UNITED STATES
DEPARTMENT OF THE INTERIOR
BUREAU OF LAND MANAGEMENTFORM APPROVED
OMB NO. 1004-0135
Expires: July 31, 2010**SUNDRY NOTICES AND REPORTS ON WELLS RECEIVED**
Do not use this form for proposals to drill or to re-enter an abandoned well. Use form 3160-3 (APD) for such proposals.**SUBMIT IN TRIPLICATE - Other instructions on reverse side.**

1. Type of Well <input checked="" type="checkbox"/> Oil Well <input type="checkbox"/> Gas Well <input type="checkbox"/> Other		8. Well Name and No. JENKINS B FEDERAL 3
2. Name of Operator COG OPERATING LLC		9. API Well No. 30-015-04216-00-S1
3a. Address ONE CONCHO CENTER 600 W ILLINOIS AVENUE MIDLAND, TX 79701		10. Field and Pool, or Exploratory LOCO HILLS
3b. Phone No. (include area code) Ph: 432-687-3033		
4. Location of Well (Footage, Sec., T., R., M., or Survey Description) Sec 20 T17S R30E NENW Lot C 330FNL 2310FWL		11. County or Parish, and State EDDY COUNTY, NM

Permanent Abandonment of Federal Wells
Conditions of Approval

Jenkins B Federal #3 Wellbore diagram.xls

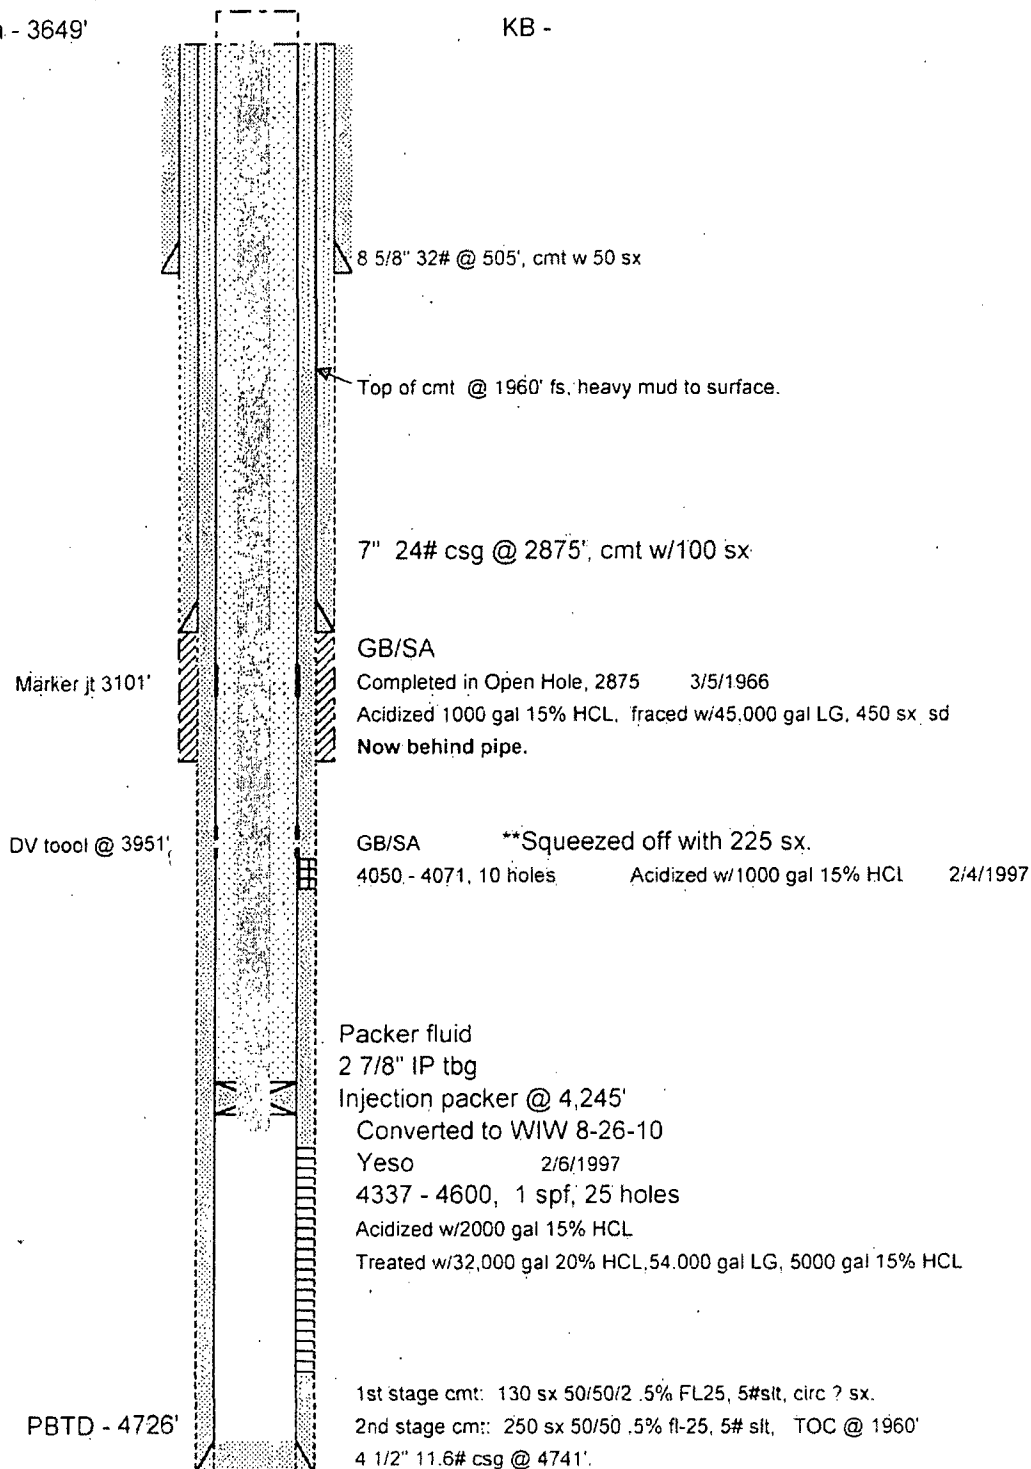
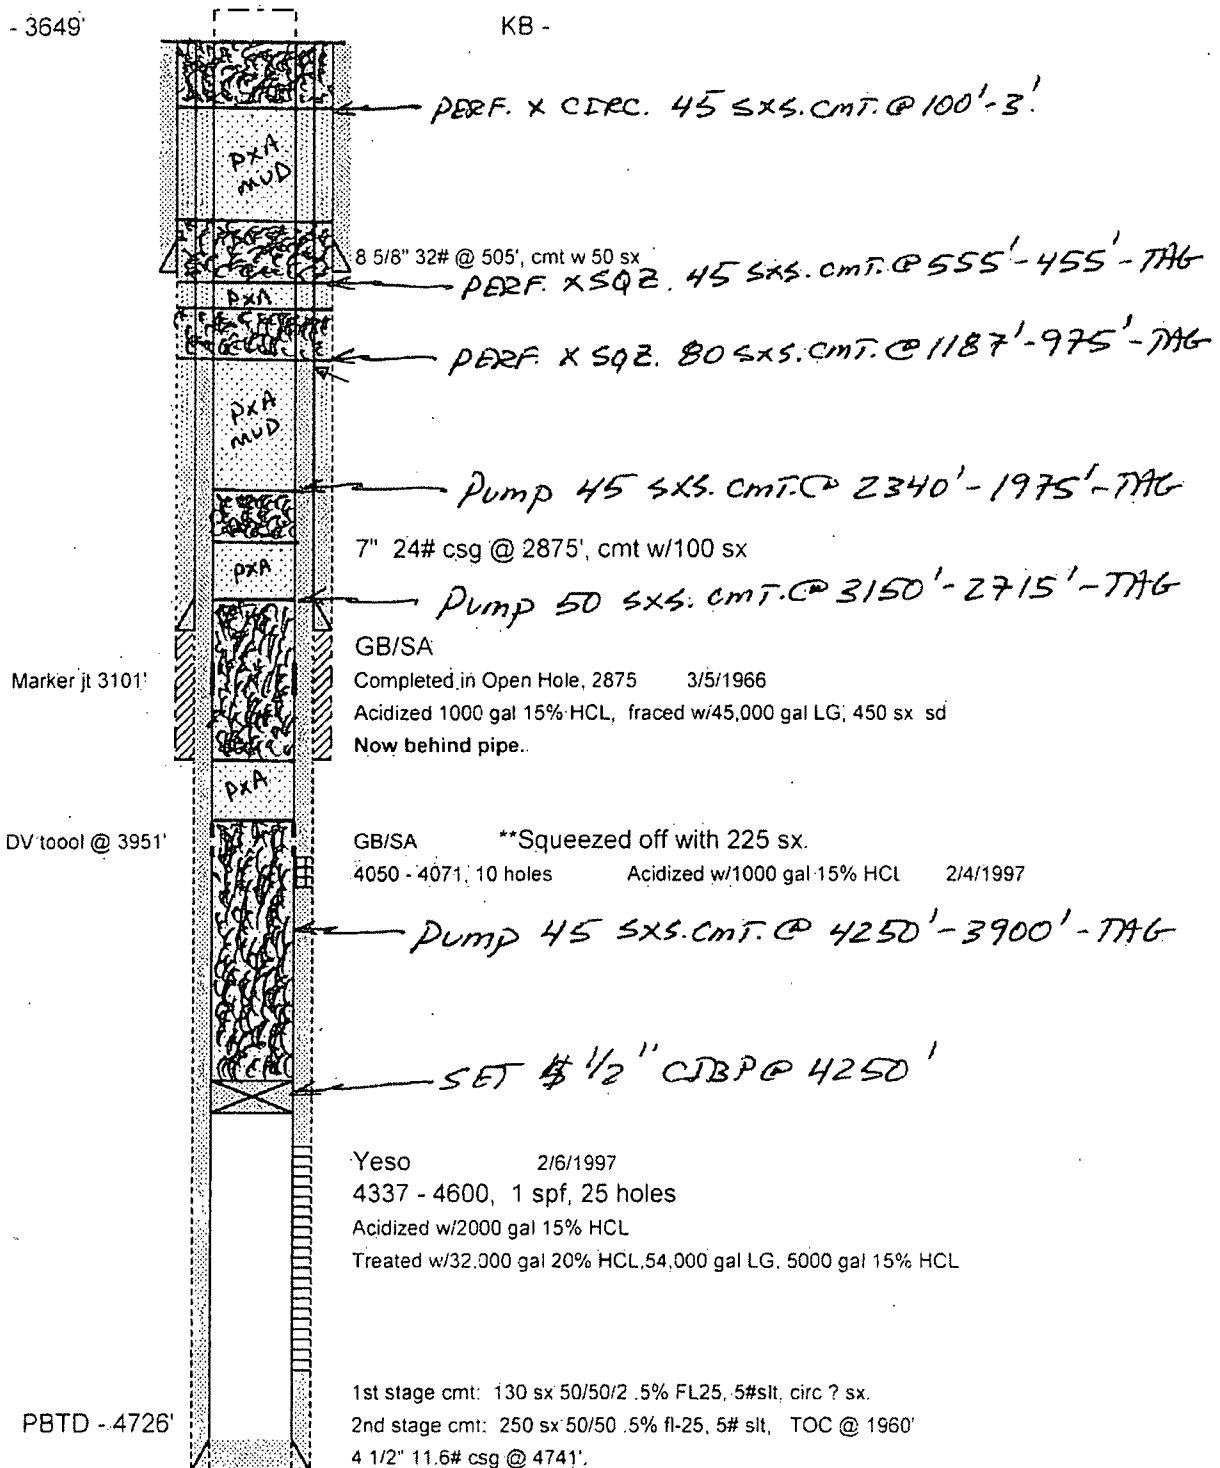
Below ground level dry hole marker required (LAC)
